## NPCC Request for Criteria Clarification

Request for a Clarification of Criteria
Date submitted: December 1, 2017 Date revised version submitted: n/a
<b>Contact information for person requesting the clarification:</b>
Name: <a href="#">Alan Adamson</a>
Organization: <a href="#">New York State Reliability Council (NYSRC) Reliability Rules Subcommittee</a>
Telephone: <a href="#">352-989-4653</a>
E-mail: <a href="mailto:aadamson@nycap.rr.com">aadamson@nycap.rr.com</a>
<b>Identify the Directory that contains the Criteria requiring clarification:</b>
Directory Number: <a href="#">Directory 1</a>
Directory Title: <a href="#">Design and Operation of the Bulk Power System</a>

Figure 1

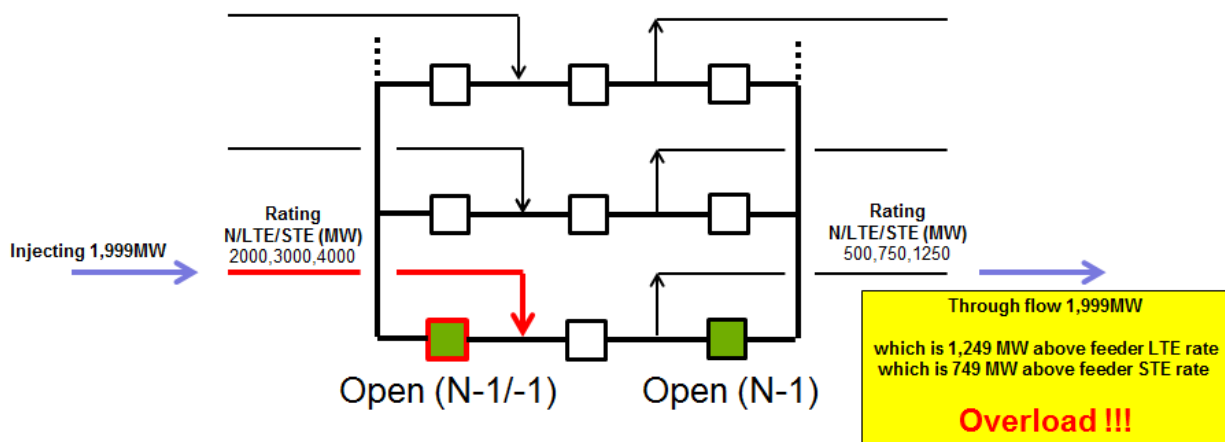
Under such N-1/-1 events, a high capacity injection (ex.: AC transmission, HVDC, or a generating unit) can be isolated onto a low rated transmission circuit (possibly loading it above its LTE or even its STE rate). Please see Figure 1 below:

1. Why does NPCC Directory 1 omit N-1/-1 event such as open breaker followed by an open breaker?

A possible solution to the identified scenario above (Figure 1)\* could be to open the middle breaker as a "system adjustment" within 30 minutes before the second contingency (in effect tripping the low rated transmission circuit). This action would eliminate the postulated overload illustrated in Figure 1.

2. Does NPCC Directory 1 postulate that the opening up of a circuit breaker falls within the definition of a "system adjustment"?
